TECHNICAL BULLETIN

Ref Document No.	TB15007	Issue No.	1
Subject	Brake Pedal Piston Pin Retaining Clips		
Release Date	21st December 2015

Purpose – Advise COALTRAM® owners/operators of a change to the retaining clips used on the brake pedal piston pin.

Figure 3: New retaining clips installed on pin

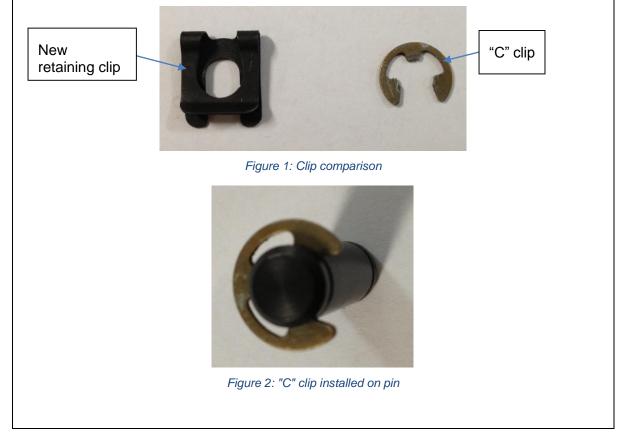
The brake pedal in the COALTRAM® is connected to the hydraulic piston via a pin retained with two "C" clips. PPK has received reports of these "C" clips detaching, allowing a possibly dangerous situation if the pin was to disengage from between the pedal and the piston.

PPK has sourced a superior clip to retain the pin which can be retrofit by only replacing the clips. The clips sourced have a tab that locks over the pin to prevent it from detaching .See images below for an illustration.

- 1. Coaltram owners/operators inspect their Coaltrams at the next available opportunity to ensure the "C" clips are in place.
- 2. At the next available service replace the "C" clips with the new retainers. Two (2) retaining clips will be required per Coaltram. Clips can be ordered from PPK Mining Equipment service part number 552009938. Follow SWP CT6.55 for retrofit procedure or contact your PPK service centre.
